**IN THE MATTER OF** Proposed Plan Change E: Roxburgh Residential  
Area to the Palmerston North City Council  
District Plan

**SUPPLEMENTARY STATEMENT OF EVIDENCE OF EAMON MICHAEL GUTHRIE AND ANDREA  
MICHELLE HARRIS ON BEHALF OF PALMERSTON NORTH CITY COUNCIL**

**Dated: 25 JUNE 2025**

## **Attachment B: Updated Modelled Shading Renders by Mr Dave Charnley**

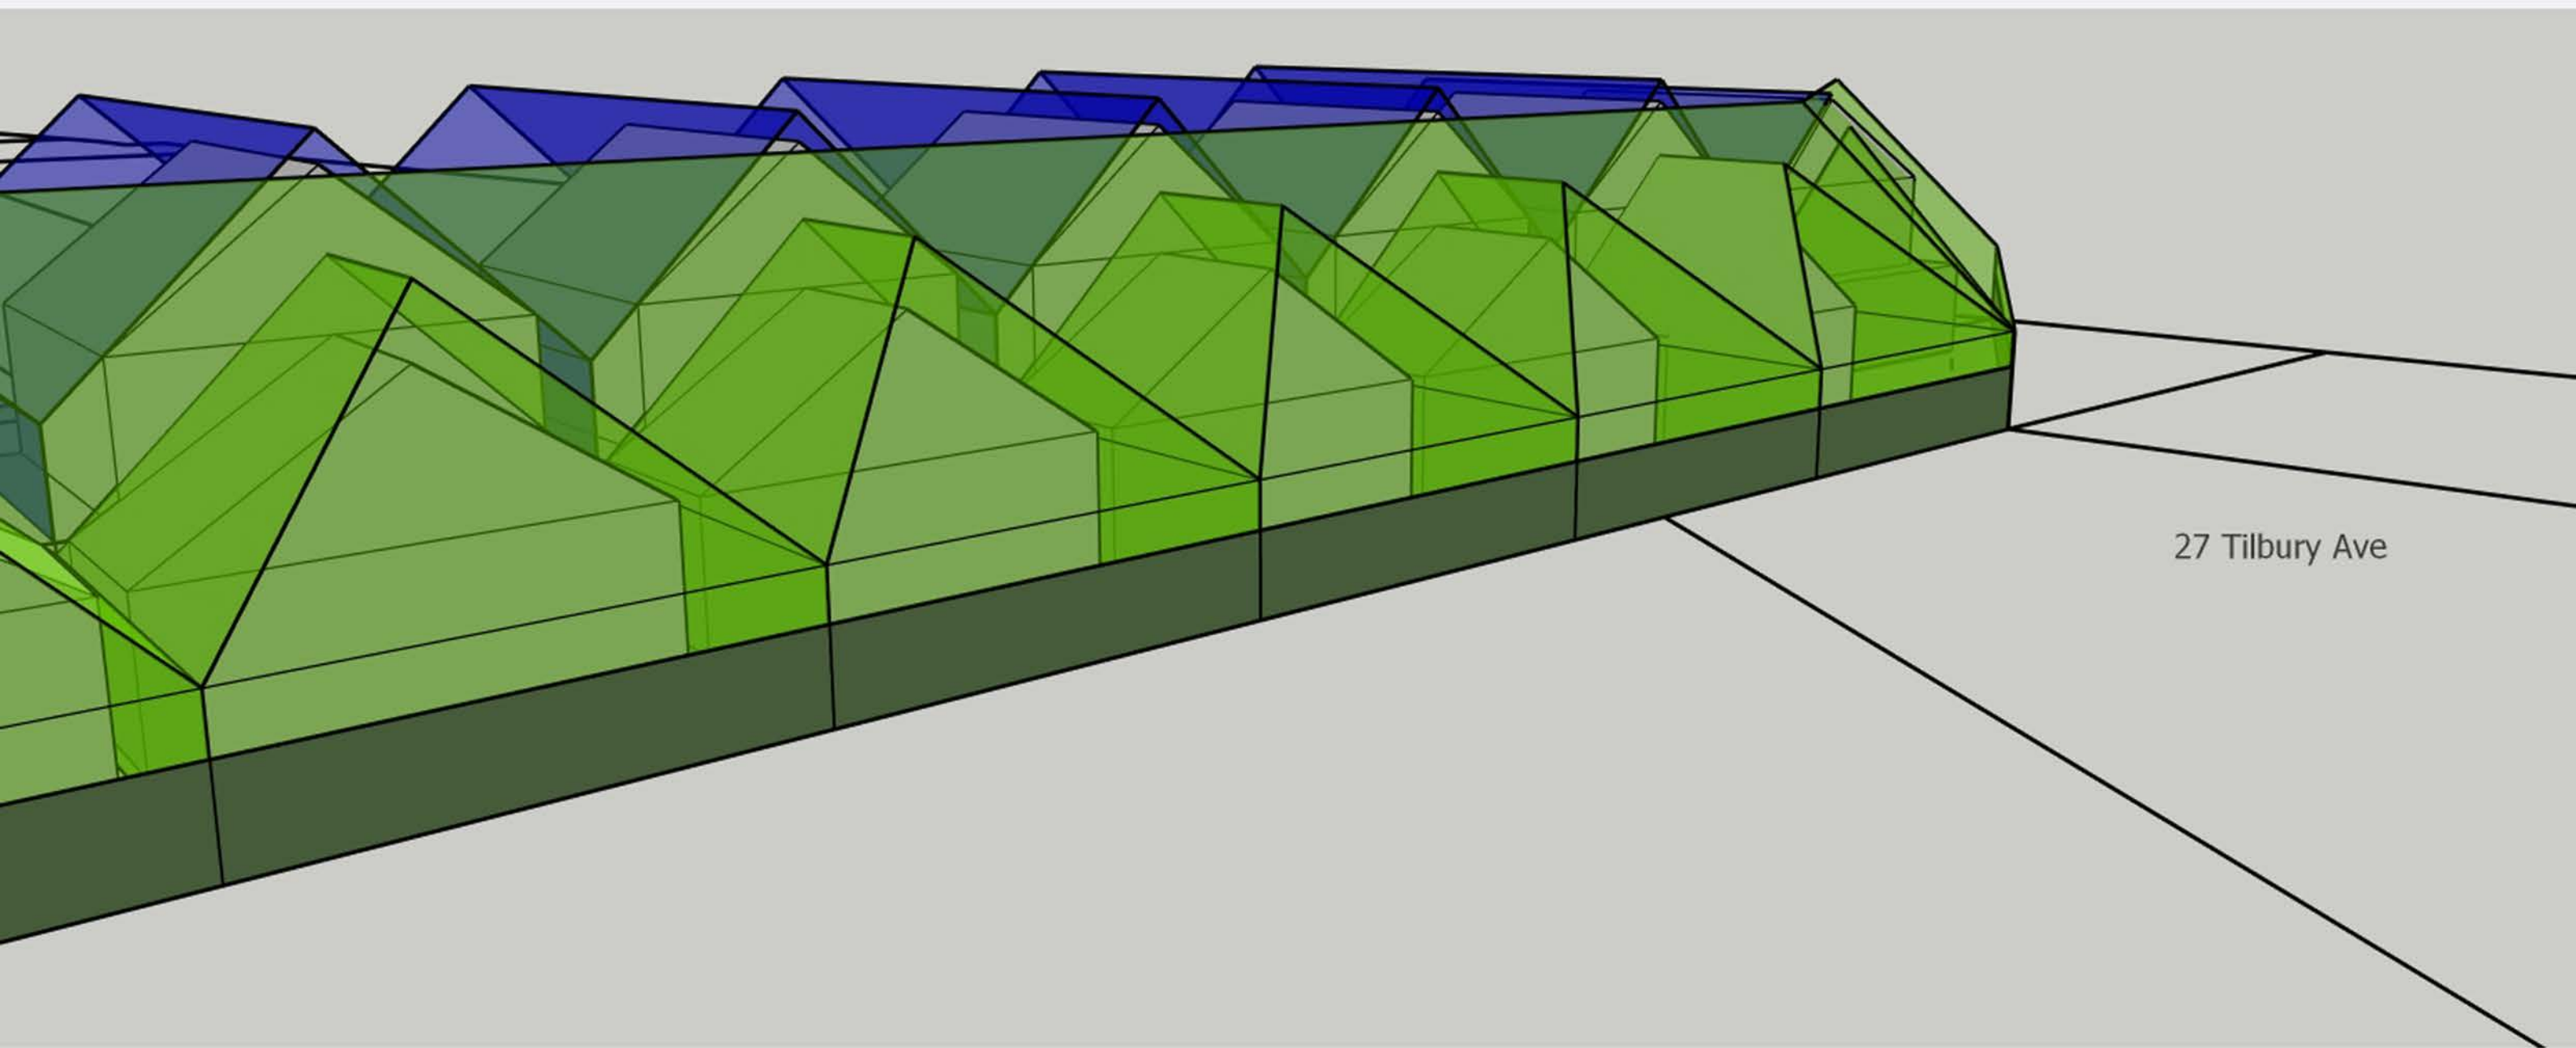
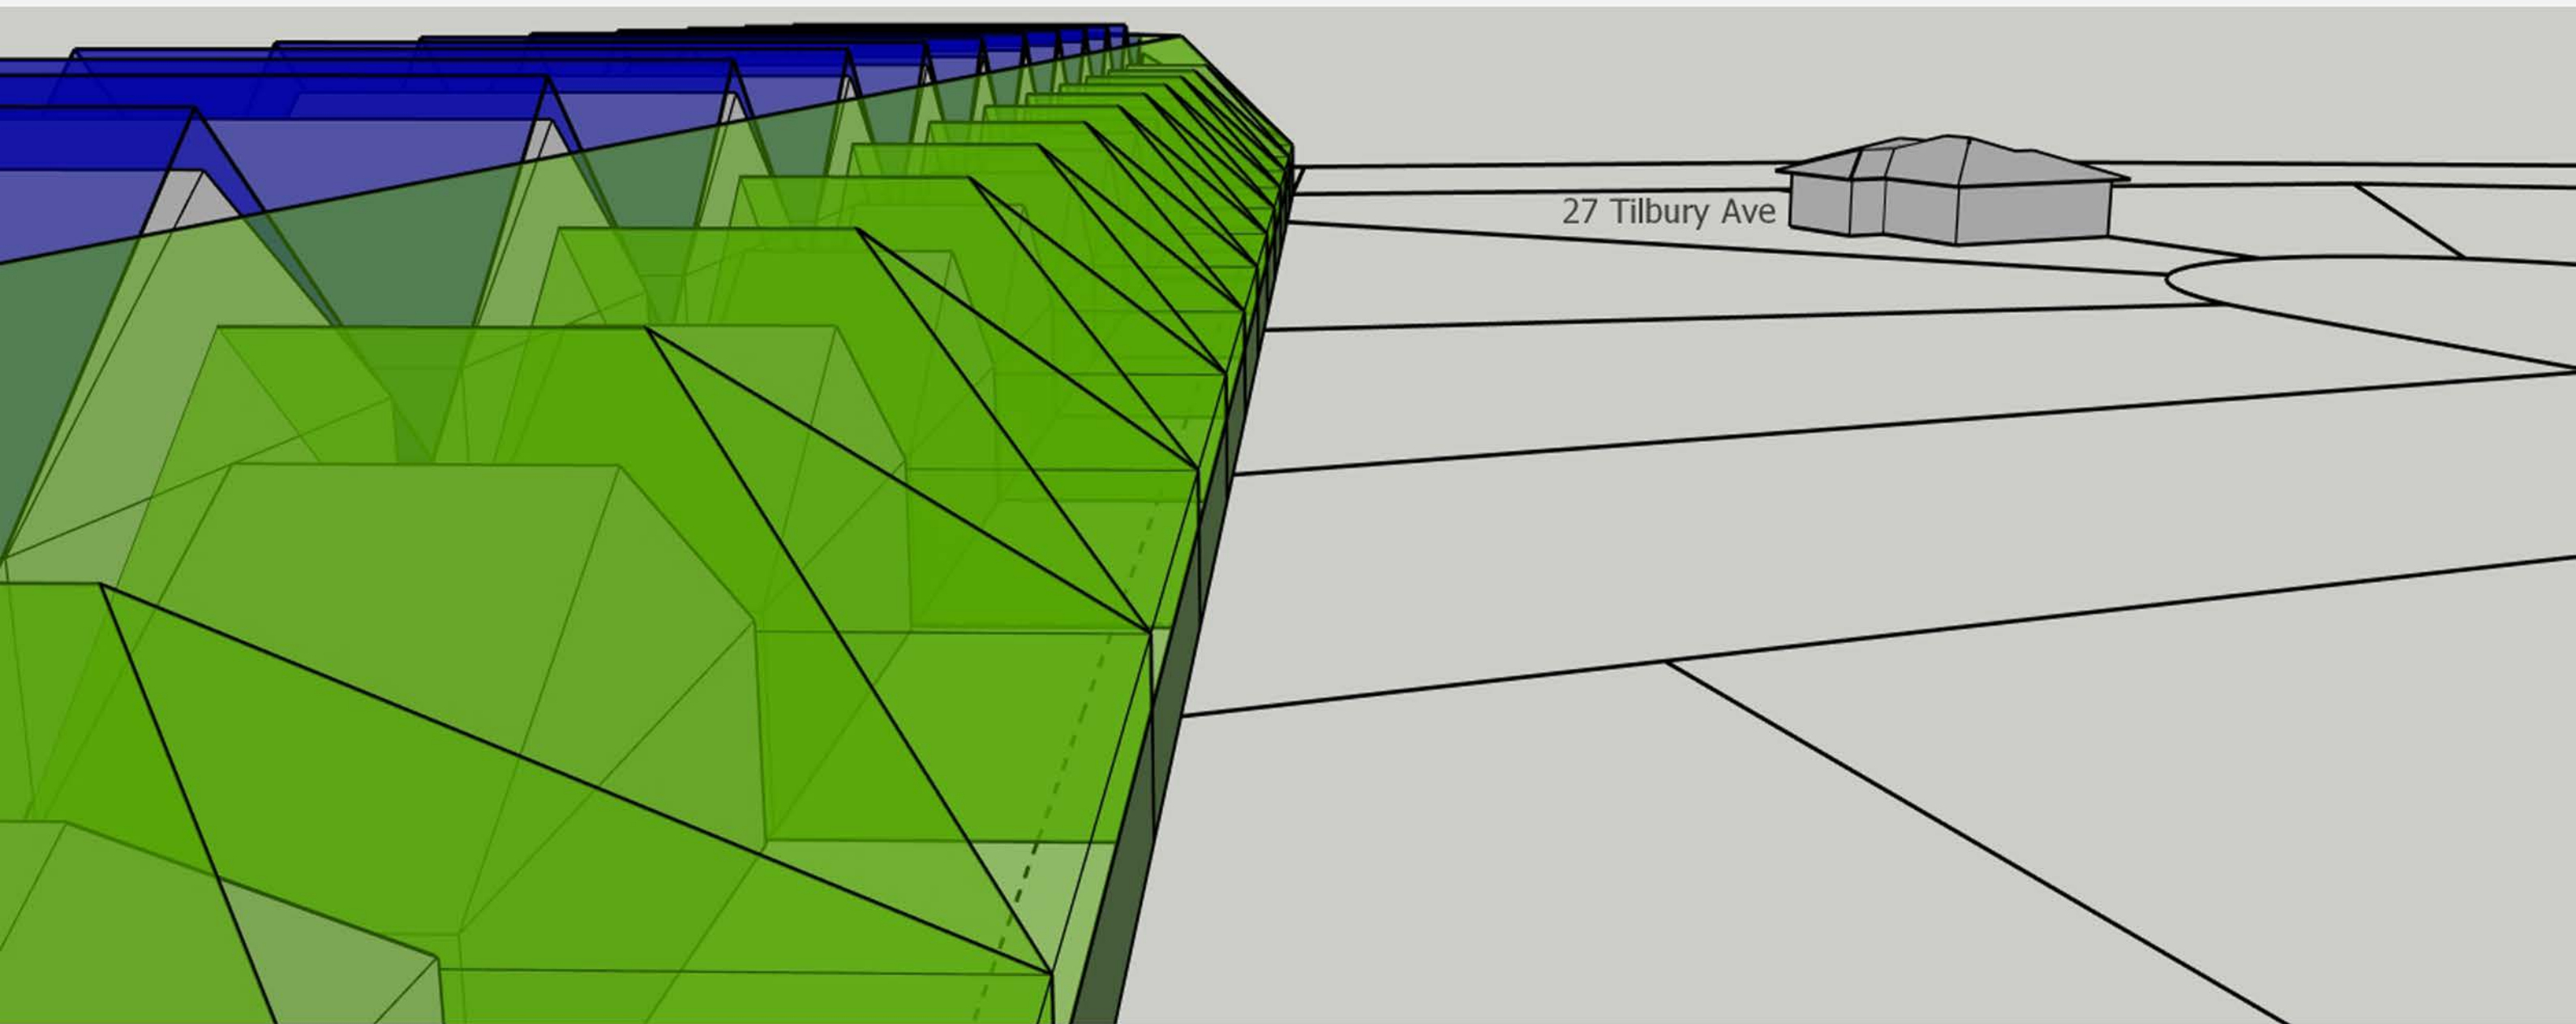
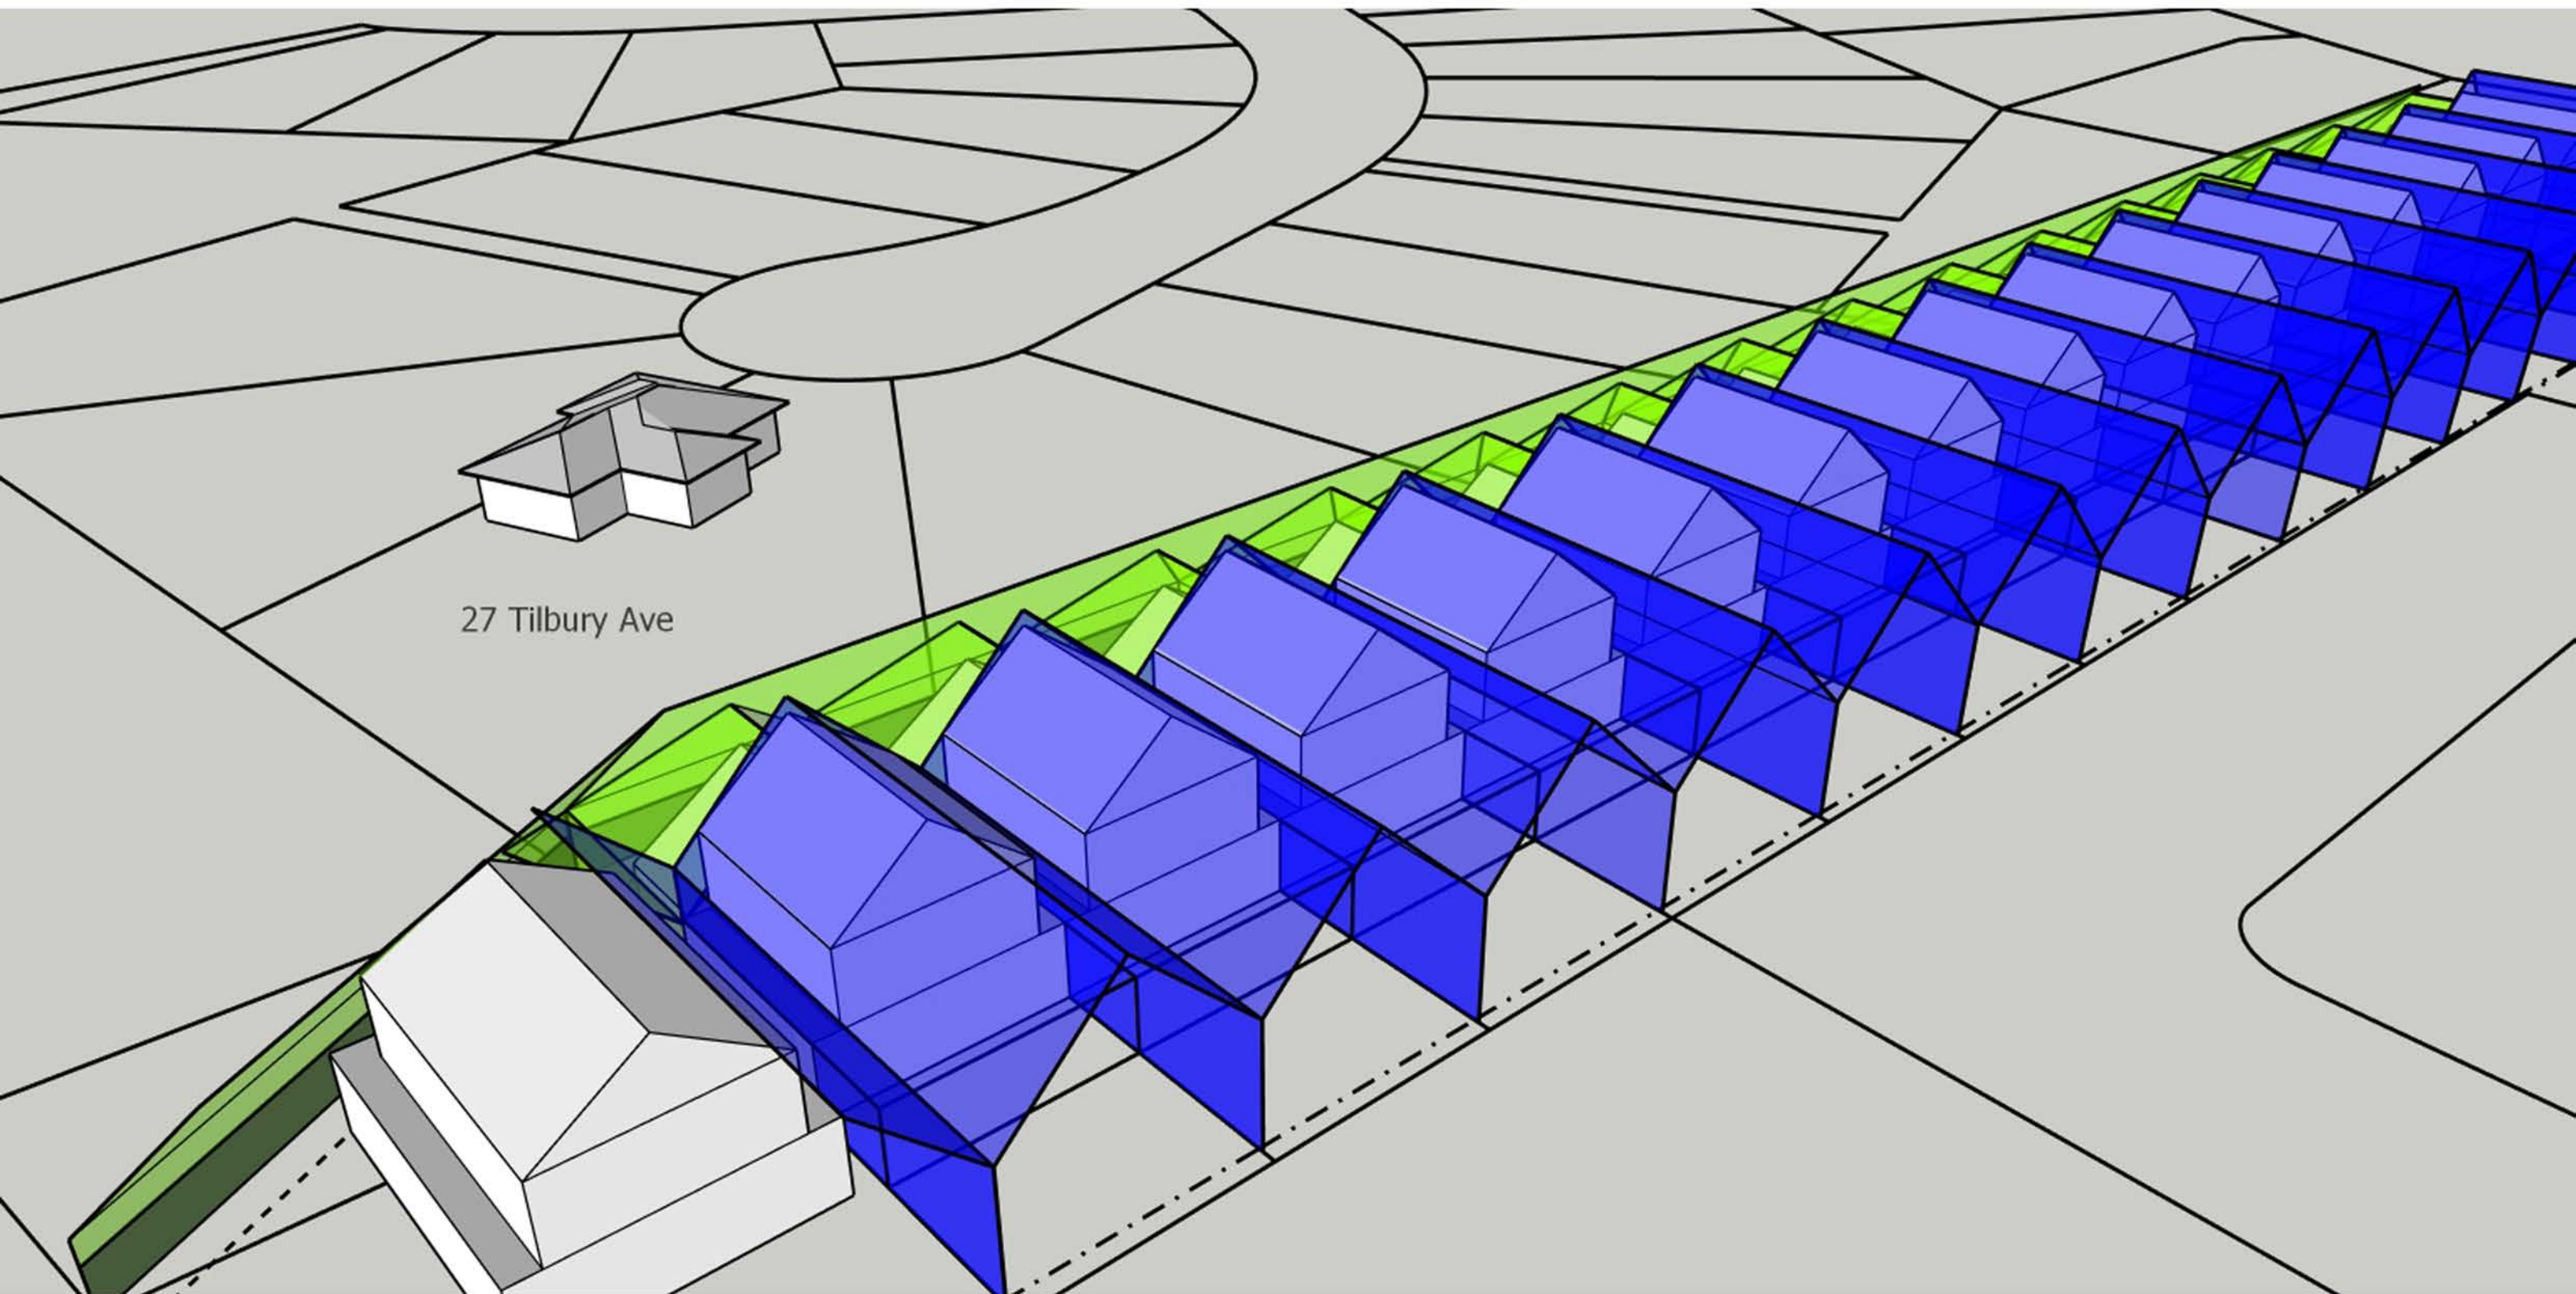
[43] In support of this approach, attached at **Attachment B**, are updated renders showing the potential shading effects on Tilbury Avenue, as a result of the revised performance standard. These have been prepared by Mr Charnley and are based on what the shading and building bulk effects may be during winter solstice along the Tilbury Avenue boundary.

[44] We consider that a separation distance of 1.5m plus a single-storey height limit within rear third of a lot is appropriate. The revised performance standard will provide a reasonable degree of privacy and bulk protections along the Tilbury Avenue interface, as was sought originally from Ms Watson. Figure 1 in the Residential zone shows a height recession plan already taking into account the elements of the proposed
